PRODUCT CHANGE NOTIFICATION (PCN)

DK-1511-001/BL MODULAR CABLE

CHANGE NOTIFICATION: PCN 20220425_DK-1511-001/BL

DESCRIPTION OF CHANGES: CHANGE OF DATA SHEET
CHANGE OF DATA SHEET
New Draw.-No. ASS_7160_CAreV04

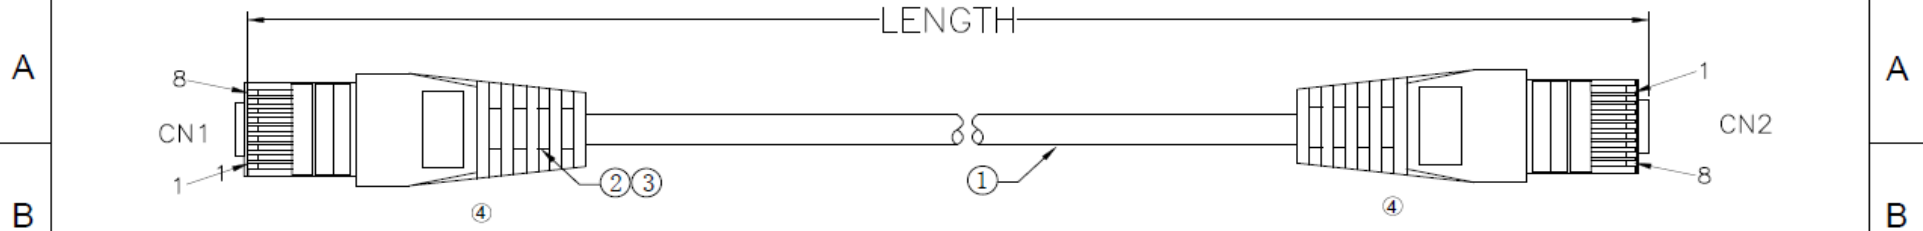
REASON FOR CHANGE: CHANGE OF PRODUCT LOCATION
CHANGE OF PRODUCT LOCATION

④		Molding PVC	2	Molding PVC 65P	④		RJ45 CONN	2	RJ45 8P8C, contacts 3u" gold-plated Un-shielded PC UL94V-2	④		CABLE	1	CAT 5E U/UTP(24AWGx1PR)*4+PVC Jacket OD:5.2±0.3mm	NO.		NAME	Q'TY	SPECIFICATION
④		Molding PVC	2	Molding PVC 65P																	
④		RJ45 CONN	2	RJ45 8P8C, contacts 3u" gold-plated Un-shielded PC UL94V-2																	
④		CABLE	1	CAT 5E U/UTP(24AWGx1PR)*4+PVC Jacket OD:5.2±0.3mm																	
NO.		NAME	Q'TY	SPECIFICATION																	
FOR DETAIL, PLEASE TAKE ATTACHED NEW DRAWING: FOR REFERENCE

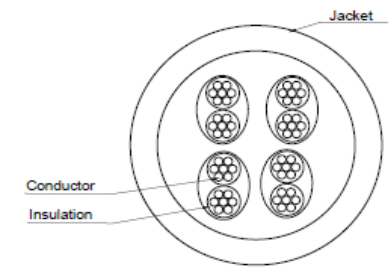
G	RoHS compliant Unit: mm	Scale	Free					Date	Name	Customer-No.	
		TOLERANCE		④	Change the plant	12.04.2022	Luca	Drawn	24.06.2014	Joanna	ASSMANN WSW-No. DK-1511-XXX/XX
		X.	±X	③	Add tolerance for cable length	20.09.2019	Amy	Approved	12.04.2022	Luca	
		X.XX		②	Add new length version	06.04.2017	Amy				
H		DIM	TOL	①	Update length version	07.12.2016	Amy	ASSMANN WSW components		Drawing-No.	
		X.°		①	Drawn	24.06.2014	Joanna			ASS 7160 CA	rev04
		Angle	TOL	Id.	Modification	Date	Name			Replace	SHEET
